2015 INITIAL ANNUAL LANDFILL INSPECTION
MITCHELL LANDFILL

KENTUCKY POWER COMPANY
d/b/a AMERICAN ELECTRIC POWER SERVICE CORPORATION
1 Riverside Plaza
Columbus, Ohio 43215

CIVIL & ENVIRONMENTAL CONSULTANTS, INC.
5899 Montclair Blvd
Cincinnati, OH 45150
(513) 985-0226

December 2015

PHOTOGRAPH LOCATION PLAN

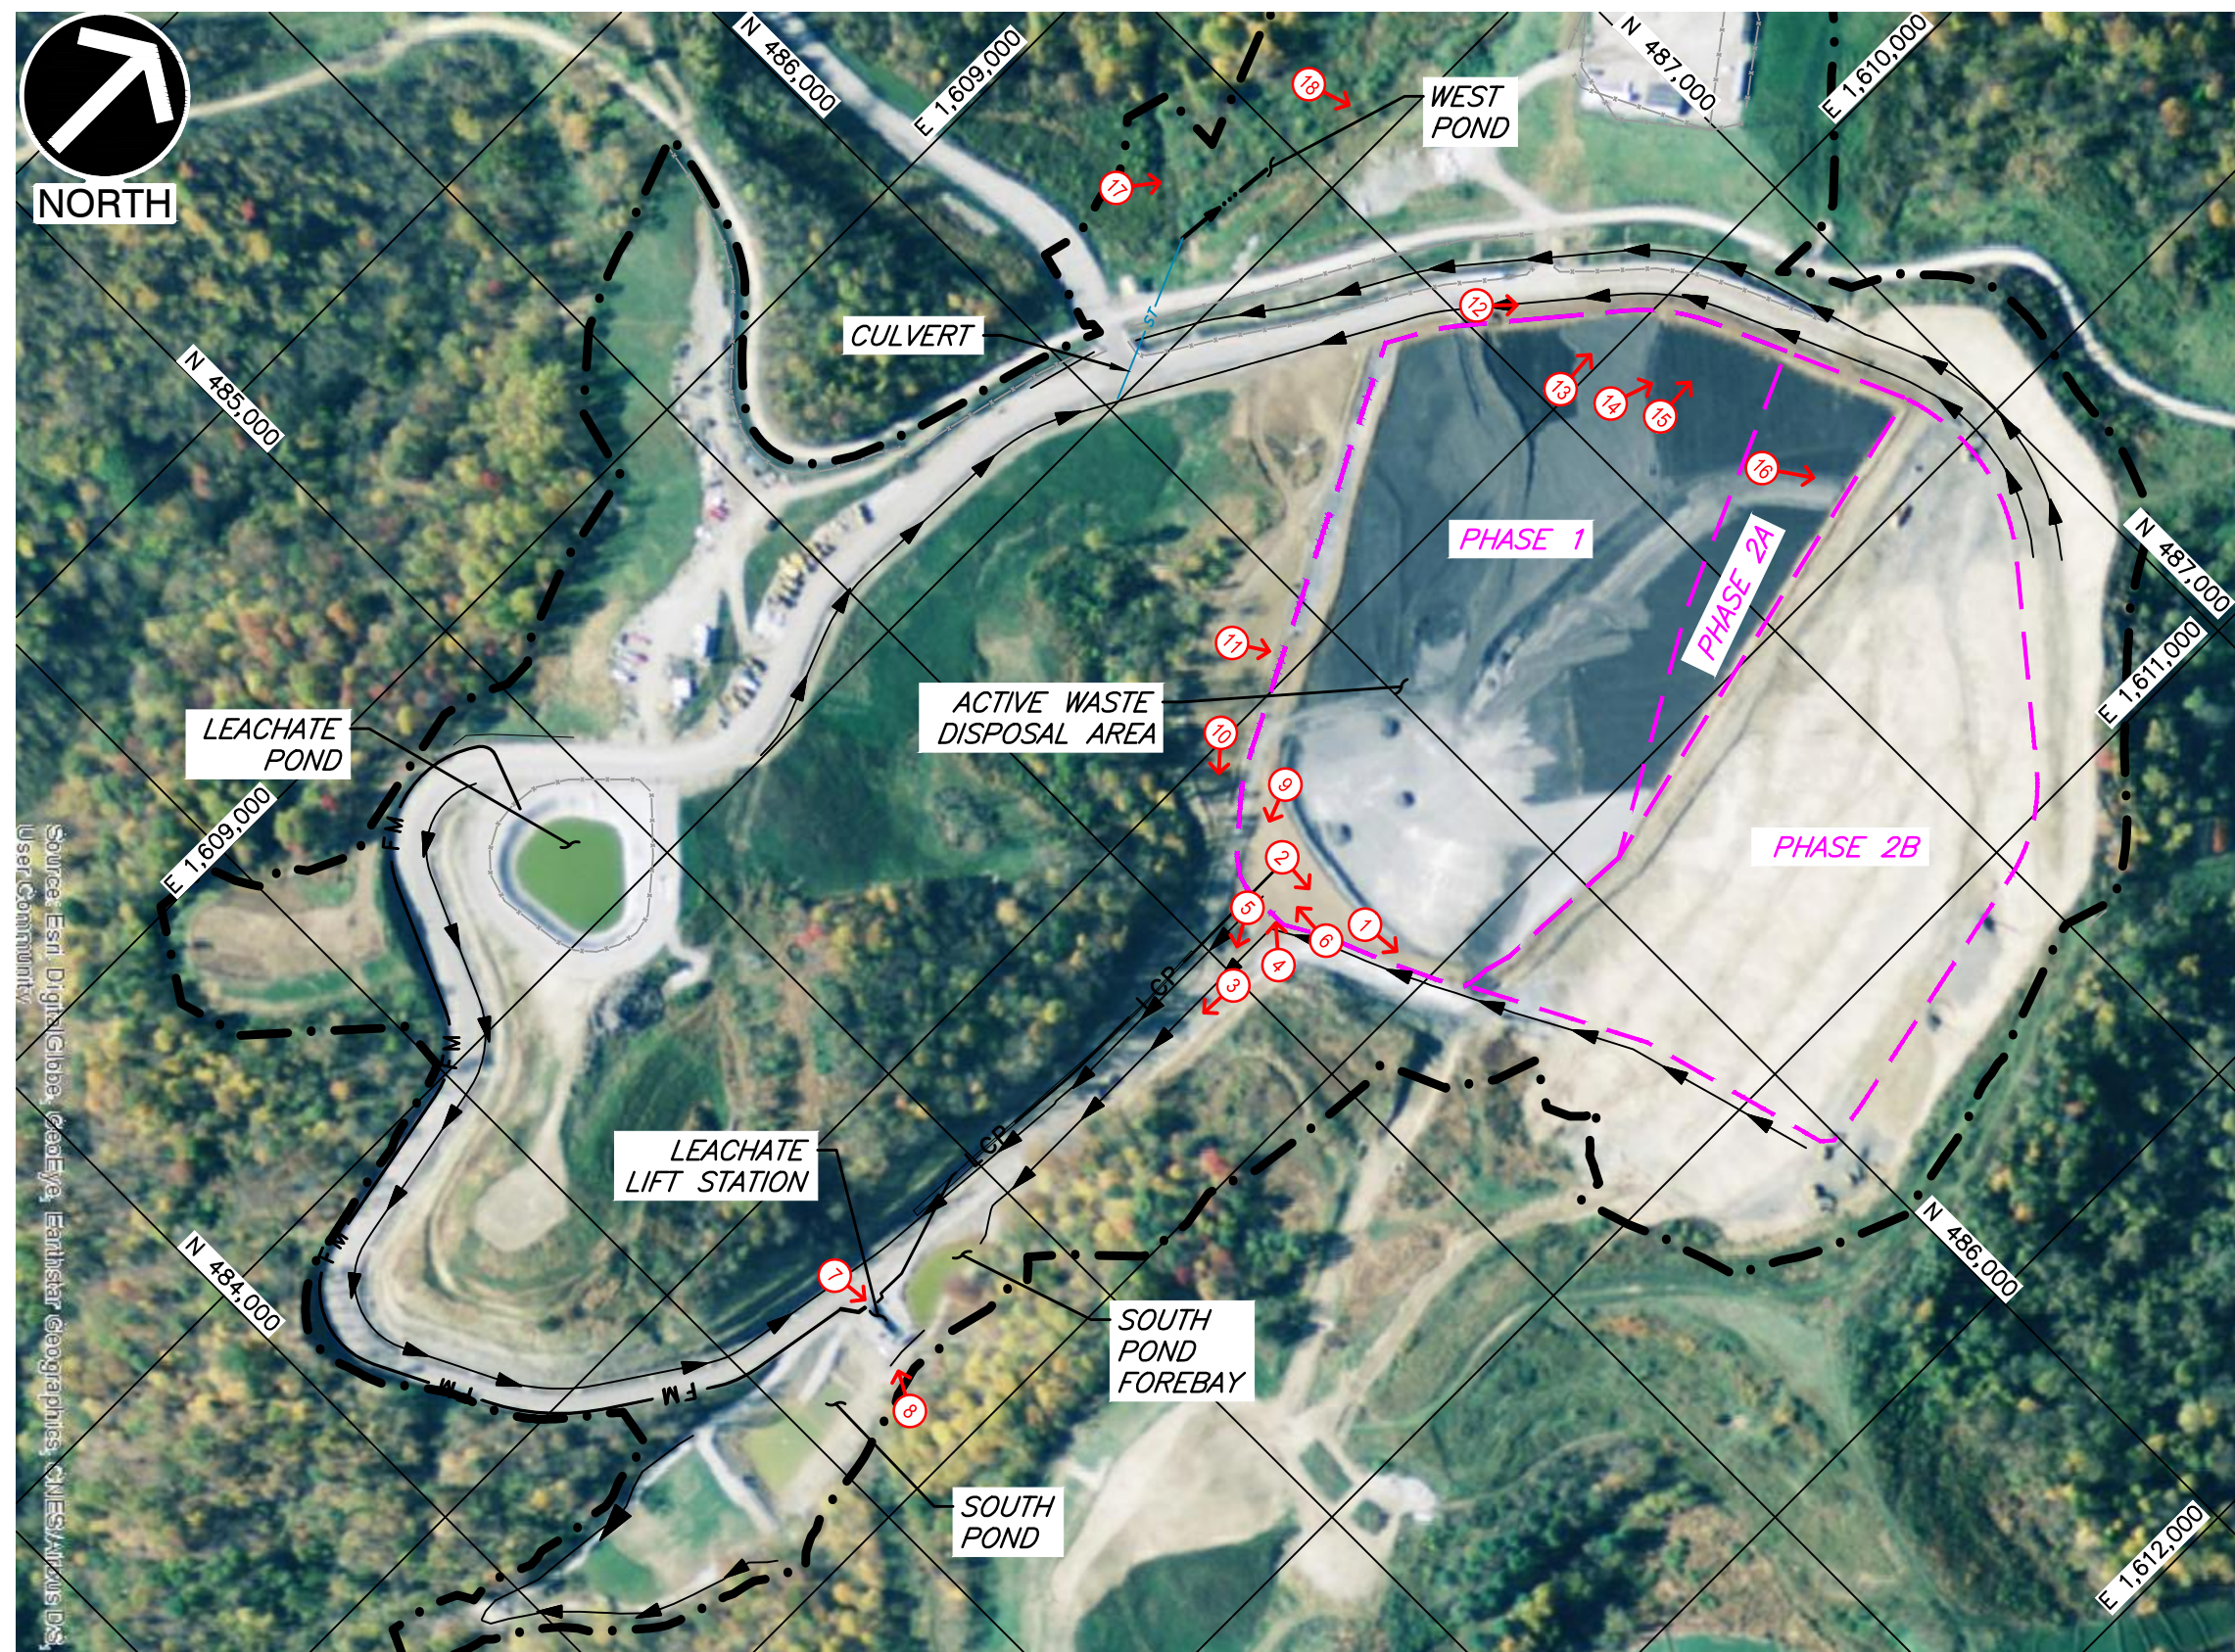
- Excessive erosion of the composite liner protective cover material was observed in the non-active landfill areas. The erosion was more prevalent on the northern slope as compared to the eastern slope (Refer to Photograph Nos. 13, 14, 15, and 16 in Appendix B).
- The haul roads observed traversing the composite liner protective cover materials within the landfill (Refer to Photograph No. 11 in Appendix B) may cause instability of the liner system.

- Localized erosion and erosion rills were observed (Refer to Photograph Nos. 2 and 10 in Appendix B).

- The outlet of the culvert pipe noted in the southeast quadrant of the pond (near top of the cut slope) is causing erosion of the newly vegetated steep slope (Refer to Photograph No. 18 in Appendix B).
- Some of the newly seeded areas around the pond did not establish full vegetative growth (Refer to Photograph No. 17 in Appendix B).
- The west pond did not have a staff gauge to readily determine the water elevation in the pond.

- An area of the forebay outlet/south pond inlet channel had been eroded of the protective riprap (Refer to Photograph No. 8 in Appendix B).
- The sediment cleanout marking was unable to be identified.

- Partial blockage of the catch basin near the south pond was noted (Refer to Photograph No. 7 in Appendix B).
- Erosion of vegetated and development of erosion rills have developed in the drainage arears positioned near the base of the Phase 1 exterior slope (Photograph Nos. 2, 9, and 10 in Appendix B).
- Localized areas of the stormwater channels located between the toe limits of Phase 1 and 2 and the south pond forebay contained sediment build up (Refer to Photograph Nos. 3, 4, 5, and 6 in Appendix B).
- The three referenced culverts (Refer to Photograph Nos. 1, 5, and 12 in Appendix B) were not included in the construction drawings and are functioning properly.

- It is recommended that the eroded composite liner protective cover materials on the north and east sides of the non-active waste disposal areas be repaired or re-established (Refer to Photograph Nos. 13, 14, 15, and 16 in Appendix B). New cover materials should be used to fill in the depressions and the exposed surface regraded to the design thickness. AEP should also consider using bottom ash for the protective cover material and/or should consider means to limit erosion in the future (i.e., sacrificial geotextile, Posi-shell application, etc.).

- It is recommended that AEP obtain confirmation that the liner stability is sufficient to accommodate the two haul roads extending from the northern end of the waste limits through Phases 1 and 2 (Refer to Photograph No. 11 in Appendix B).

- It is recommended that a designated armored channel be constructed from the inlet pipe headwall located in the southeast quadrant of the west pond (near the top of the steep slope) to the west pond (Refer to Photograph No.18 in Appendix B).

- It is recommended that the riprap armoring for the channel from the south pond forebay to the south pond be repaired (Refer to Photograph No. 8 in Appendix B). New riprap material should be placed as required to re-establish the design thickness.

- It is recommended that the three culverts noted in Section 3.3.5 (Refer to Photograph Nos. 1, 5, and 12 in Appendix B) be evaluated to determine if adequate flow capacity in the channels exists. It is also recommended that inlet/outlet protection be constructed and that existing sediment and blockages be removed from the upstream and downstream ends. Subsequent to final repairs, it is recommended that the ground surface near these structures be stabilized.
